FUSELAGE UPPER LONGERON INSPECTION AND REPAIR

MODELS AFFECTED: Model S2R, S/N 1416R thru 2574R
Model S2R-R1340, S/N 1340-001 thru R1340-010
Model S2R-R3S, S/N R3S-001 thru R3S-010

REASON FOR PUBLICATION: Preclude possible fatigue failure of the upper fuselage longeron.

FIGURE 1

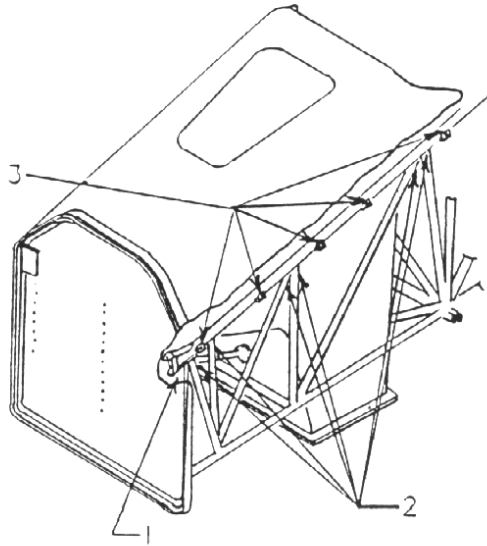
1. Remove the fuselage side skin located between the wing upper surface and the hopper. This will provide access to the upper longeron from the firewall to the cockpit.
2. Visually inspect the longeron paying particular attention to: (See Figure 1)
 1. Area around the upper engine mount attach points.
 2. Each vertical diagonal tube intersection at the upper longeron.

3. Each hopper attachment bracket.
3. If no cracks are found, fill out and mail Compliance Card noting that no cracks were found. Proceed to Record Compliance and return aircraft to service.
4. If cracks are found, fill out and mail Compliance Card noting that cracks were found, then proceed to Part II.

FIGURE 2

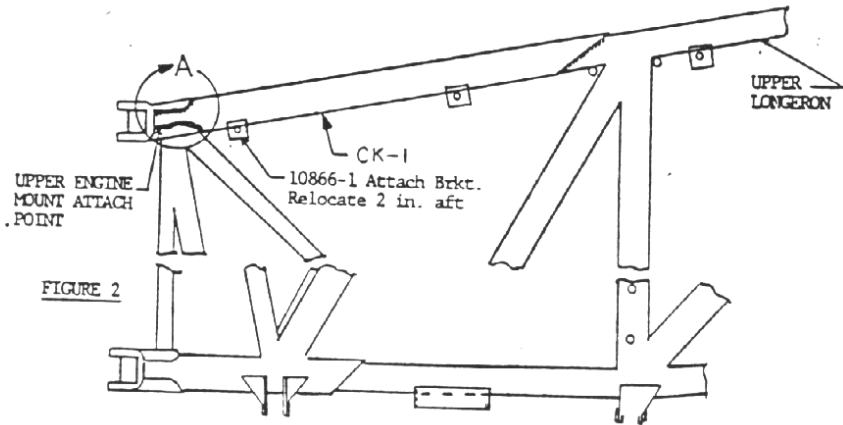
1. If any cracks are found, remove hopper and attaching parts. Weld cracks closed in longerons. Obtain Custom Kit No. CK-AG-19 from Ayres Corporation.
2. Grind off the four 10866-1 Attach Brackets, See Figure 2.

4. Clamp the split sleeves in position and weld as shown in Figure 2.
5. Grind the fiberglass in the hopper saddles as necessary to allow the hopper to be lowered onto the longerons in the original hopper location.

6. Locate and weld the forward attach brackets 2 inches aft of its original location. Locate and weld the aft attach brackets at its original location (plus or minus ½ inch). Use a straight edge resting on the remaining (aft) brackets to obtain lateral alignment of the replacement brackets.

FIGURE 3

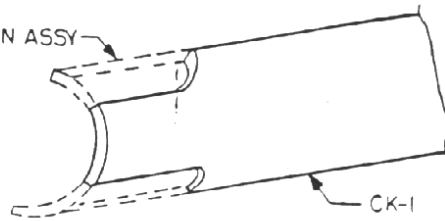
3. Grind or nibble the ends of the sleeve tubes P/N CK-AG-19-1 and -2 to fit snugly within the original weld beads at the forward tube clusters/gussets at the firewall. See Figure 3.
